UNITED STATES
NUCLEAR REGULATORY COMMISSION
WASHINGTON, D. C. 20555

FACILITY: THREE MILE ISLAND UNIT NO. 1 (TMI-1)

SUMMARY OF MEETING HELD ON NOVEMBER 5, 1976, TO DISCUSS INSTALLATION OF COMPACT SPENT FUEL STORAGE RACKS AT TMI-1

RACK PLAN VIEW

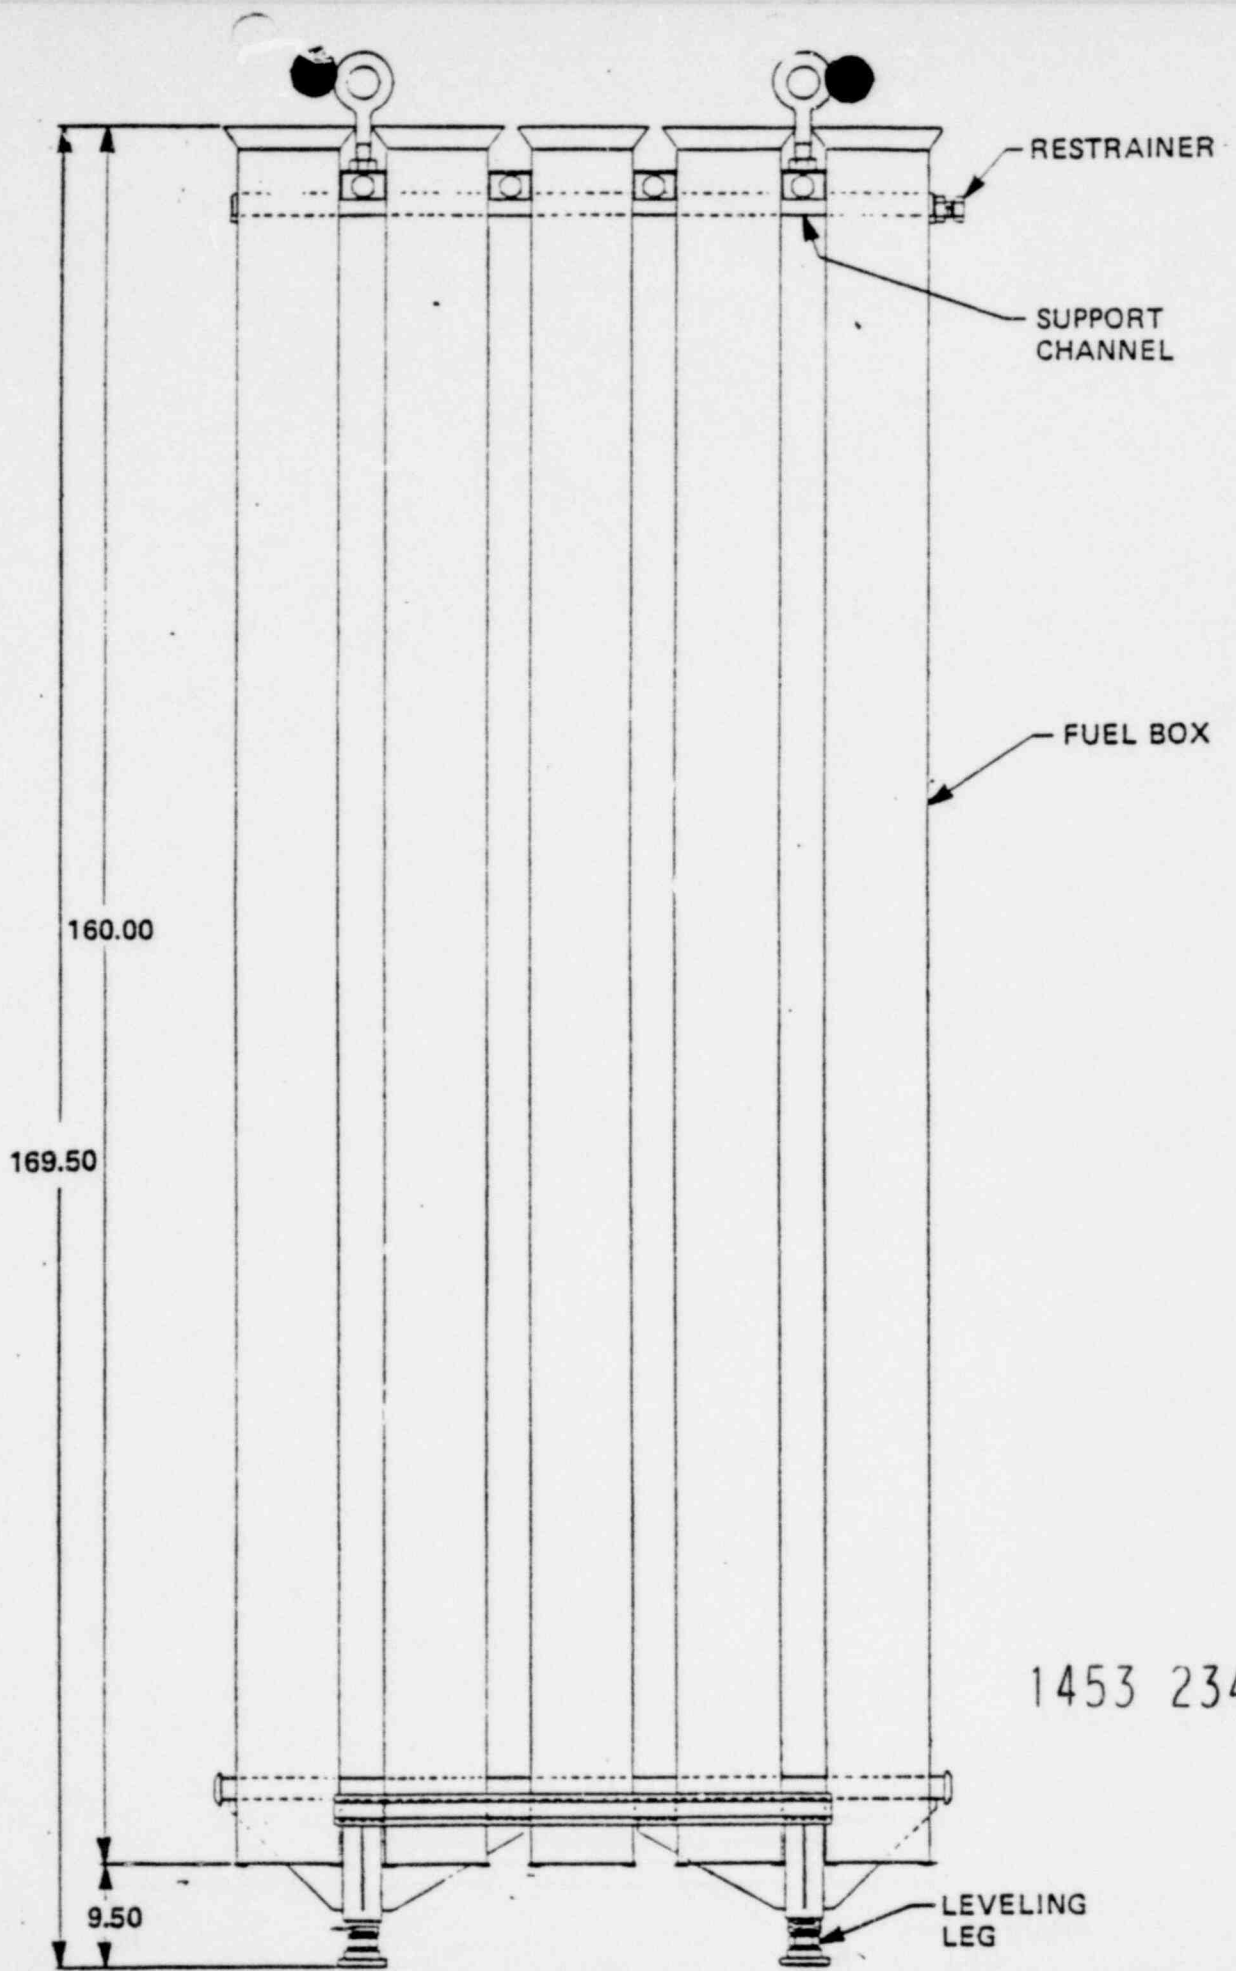
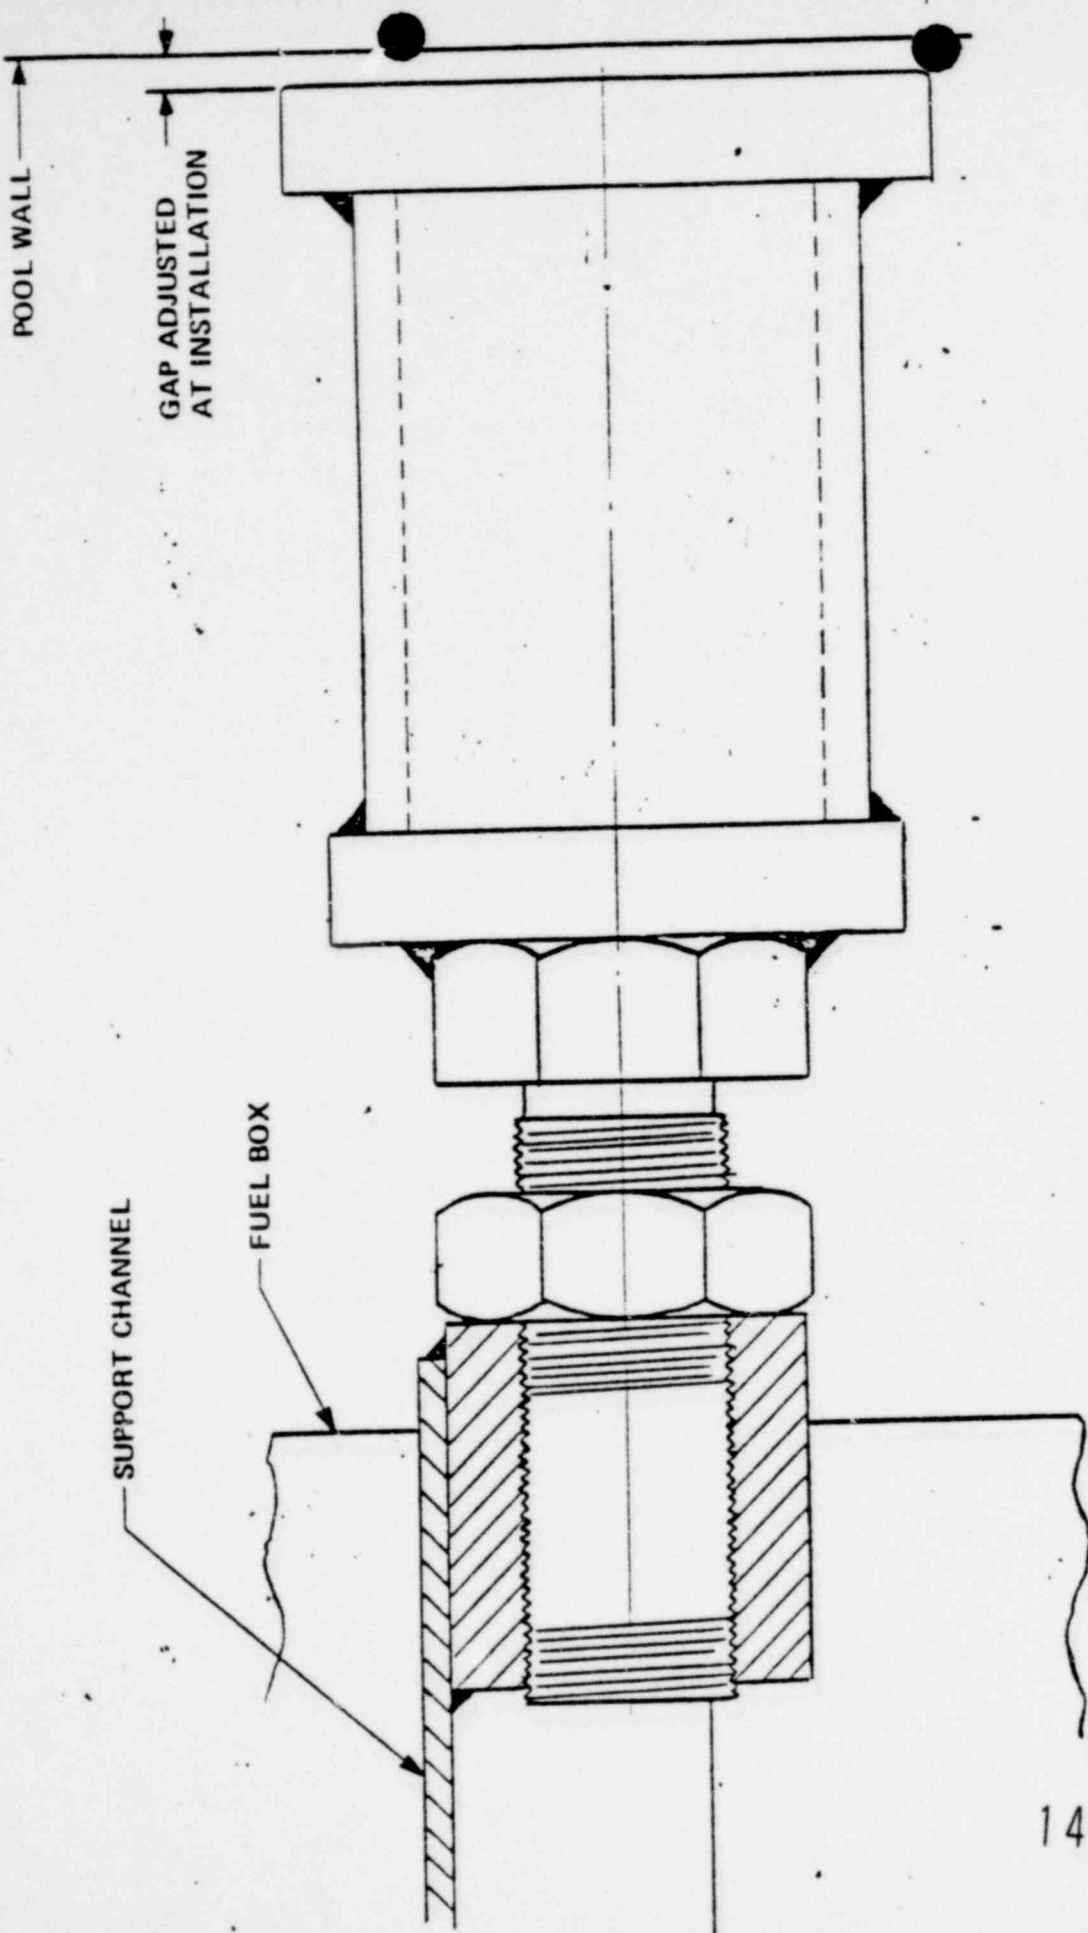
- 1) To facilitate review of the planned modification, the licensee should provide more detailed sketches of the racks and their vertical and horizontal restraints and interfaces with the pool walls and floor.
- 2) Also to facilitate review, the licensee should submit a more detailed description of the non-linear seismic analysis, including data on the natural frequencies of the fuel elements, the storage cans, the floor response spectra and time histories utilized in the analysis.
- 3) Any new pumps or other components added as part of this modification should be qualified per currently applicable codes and regulations.
- 4) The analysis should address any stresses arising as a result of liner buckling.
- 5) The analysis should demonstrate the adequacy of the pool floor design to accommodate the added load imposed by the new storage rack design.
